Alert Service Bulletin No 33

(a) No.:	33
(b) Revision / Date	2 / June 2023
(c) Title:	CB2990 Issue A (Alugas) Cylinders - Withdrawal from service
(d) Description:	Permanent withdrawal from service of CB2990 Issue A (Alugas) cylinders
(e) Applicability:	All hot-air balloons (from all manufacturers) fitted with CB2990 issue A (Alugas) cylinders
(f) Effectivity:	Fuel cylinders Part Number CB2990 Issue A (Alugas) cylinders having serial numbers: OC25001 to OC25202 Q114001 to Q114496 Note 1: This serial number range covers all CB2990 Issue A (Alugas) cylinders. Note 2: CB2990 Issue B (Alugas) cylinders are not affected by this bulletin These fuel cylinders are known to be installed on, but not limited to, hot-air balloons and airships manufactured by Cameron Balloons Ltd, Colt Balloons, Lindstrand Balloons Ltd (LBL), Lindstrand Hot Air Balloons Ltd, Sky Balloons, Thunder Balloons, and Thunder & Colt

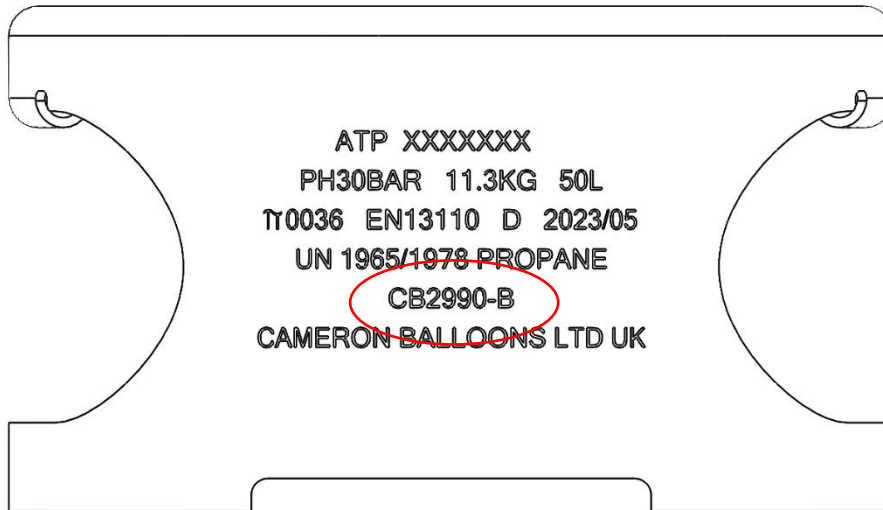
A number of CB2990 Issue A (Alugas) cylinders developed cracks in the weld between the cylinder valve plate and the upper dished end. These cracks allow the release of propane from the cylinder.

The CB2990 Issue B Cylinder can be differentiated from the withdrawn CB2990 Issue A cylinder in the following ways:

Cylinder part number: The cylinder part number is stamped on the upper guard ring of the cylinder: The issue B cylinder carries the part number CB2990-B, the withdrawn Issue a Cylinder carries the part number CB2990/A

Cylinder Valve Plate: The cylinder valve plate of the CB2990 Issue B cylinder is raised above the dished end of the cylinder and has raised valve bosses. The Issue A cylinder valve plate has a flat top and is welded flush with the dished end.

Affected (i.e. Issue A) Cylinders are prohibited from further flight and are unsafe for the storage of LPG. Affected cylinders must be emptied, permanently withdrawn from service, and rendered unsuitable for storing LPG.
